TECHNICAL INFORMATION

No:	12/02/99/NAS
Ref:	
Issue:	1
Date:	06/18/99

Intake Manifold Gasket Leaks

Figure 1

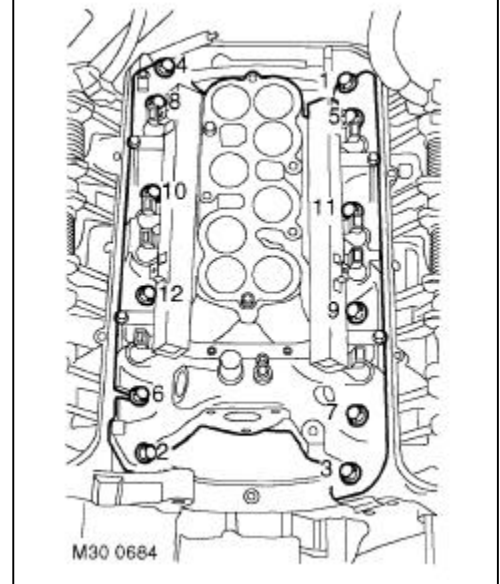
LOOSE INTAKE MANIFOLD BOLTS MAY CAUSE MANIFOLD GASKET LEAK

A customer may complain of poor engine idling, stalling, hesitation or other engine performance-related issues. A leaking intake manifold gasket joint may be the cause, due to rear intake manifold bolts that may have stretched during factory installation. A stretched bolt may not reach the specified peak torque of **51 Nm (38 lbf.ft.)**.

1. Refer to WSM 12-2-43 and perform the following repair sequence:
 - Remove intake manifold bolts, noting the proper removal sequence (Figure 1).
 - Remove intake manifold.
 - Replace intake manifold gasket.

REPLACE INTAKE MANIFOLD BOLTS WITH NEW SPECIFICATION BOLTS

Stronger intake manifold bolts (LYG101450, LYG101440) have been introduced. The new bolts can be identified by the letter "V" stamped on the bolt head. Using new-specification unstretched bolts permits tightening to the correct torque and will provide a proper repair.
